Surveillance Report

Package / Item:	Bascule span to the Railway bridge "Jernbanebroen over Limfjorden"
Supplier:	MT Højgaard
Purpose of visit:	Production & Quality Surveillance – Steel structure
Location / Address:	Tarcon Tarnobrzeg Poland

Date of Visit / Review: 2011-09-15 to 2011-09-16

Shop drawings from MT Højgaard Vietnam

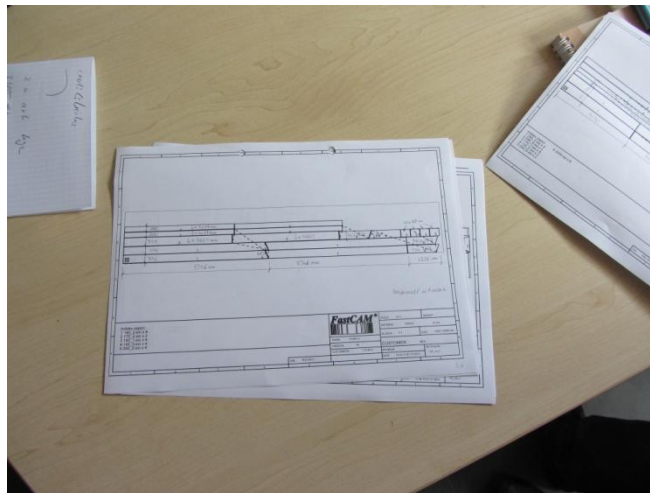
Examples of shop drawings from MT Højgaard Vietnam and cutting drawings from Tarcon were shown at the meeting. On the drawing note Rambøll shall be changed to MT Højgaard Vietnam. Based upon a trial test, Rambøll has no further comments.

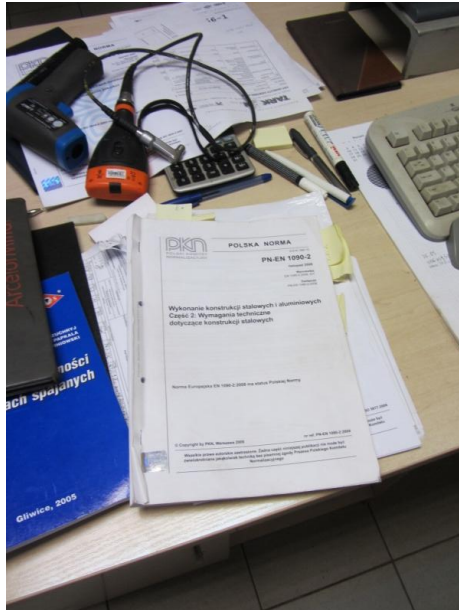
Tarcon/MT Højgaard shall forward a verified WPS for site welds. This shall include necessary weather protection suitable for the decided weld process. Tarcon informed Rambøll that joint preparation including sandblasting will be finished at shop. The steel profiles will be covered by adhesive plastic. The description of an appropriate treatment of the field weld zone will be forwarded.

To short tack welds on profiles to another project

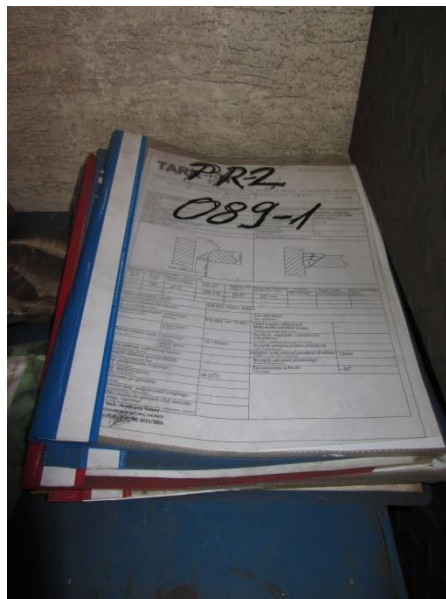
Rambøll informed that tack weld shall be removed when performing final welds, this shall be stated on the shop drawings. The length of tack welds shall be minimum 50 mm according to EN 1090-2 section 7.5.7. The tack welds shall be preheated according relevant WPS.
